DEPARTMENT OF MECHANICAL ENGINEERING
THE UNIVERSITY OF TEXAS AT AUSTIN

Ref: Facility License R-129, Docket 50-602
ANSI/ANS 15.1, *The Development of Technical Specifications for Research Reactors*

Subject: Requested changes to Section 6.0 of Technical Specifications

6.1.1 Structure

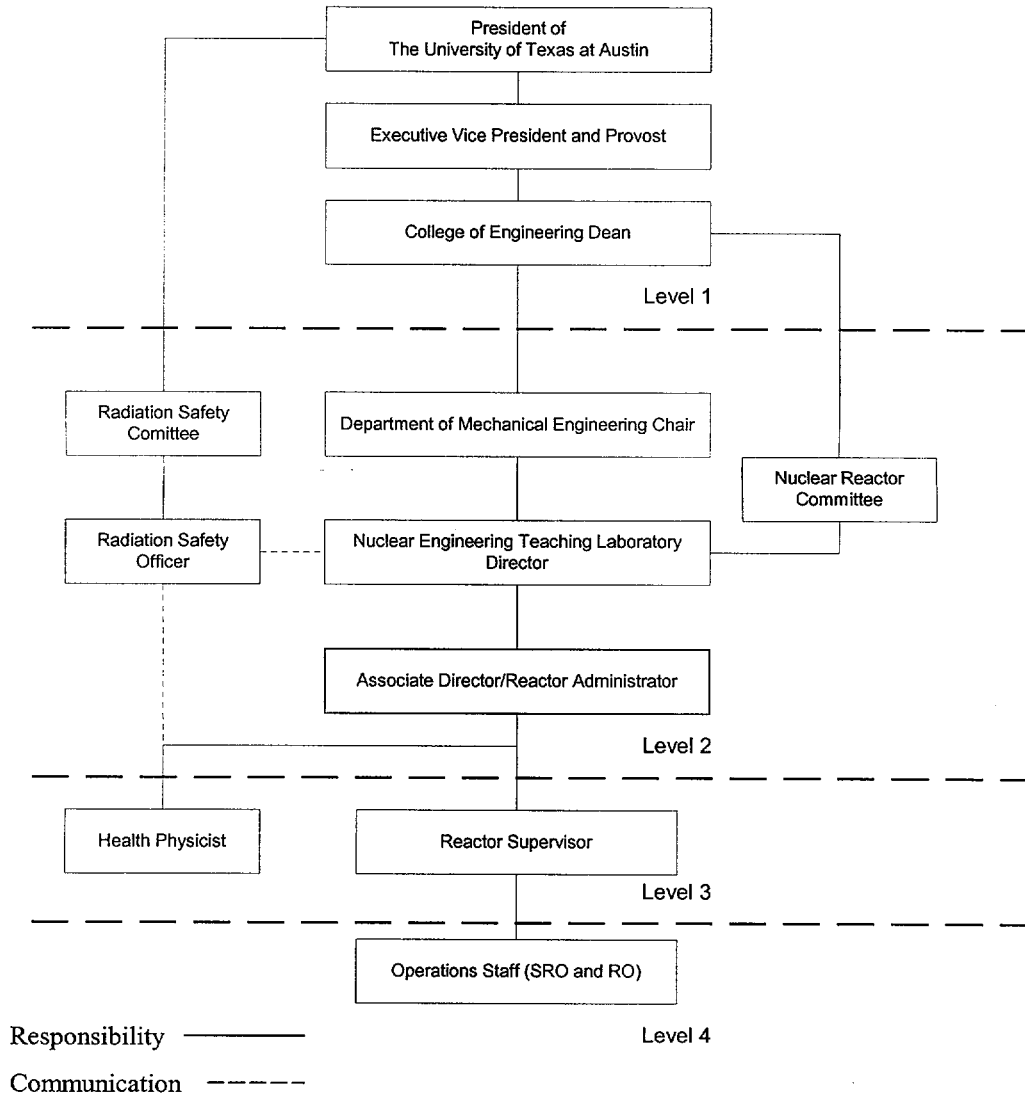
The management structure of the NETL was modified in 1999 to include the position of Associate Director. This position manages the daily facility operations and directly supervises the Reactor Operations and Health Physics groups. The Associate Director is therefore directly responsible for the facility and is delegated to act as NETL Director in his absence. An audit in November 2000 noted the Facility License, Security Plan and Emergency Plan did not address the change in NETL management structure and responsibilities and recommended immediate corrective actions. The changes are consistent with ANSI/ANS 15.1. The NETL requests the following modification to Section 6.1.1 and 6.1.2 of the Technical Specifications:

The facility shall be under the control of the Director, Associate Director or a Senior Reactor Operator. The management for operation of the facility shall consist of the organizational structure as follows:
